Lloyd's Register of Shipping.

Ship's Name EMMA BAKKEOfficial No. 7554

Memorandum of alterations reported since ship was surveyed for assignment of Load Lines
in JUNE, 1932.

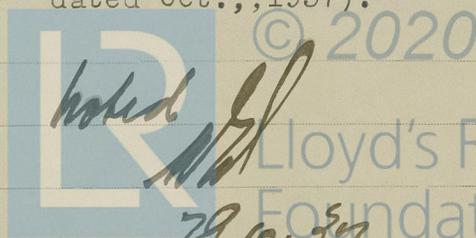
The overboard scuppers from the 2nd deck have been removed.

Holes in shell plating and in deck stringer plates permanently closed and a 5" screw down scupper valve, operated from upper deck has been fitted on each side in the tonnage well.

Freeing ports in tonnage well also closed for good.

There are two drain pipes each side from the shelter tween deck space to engine room bilges.
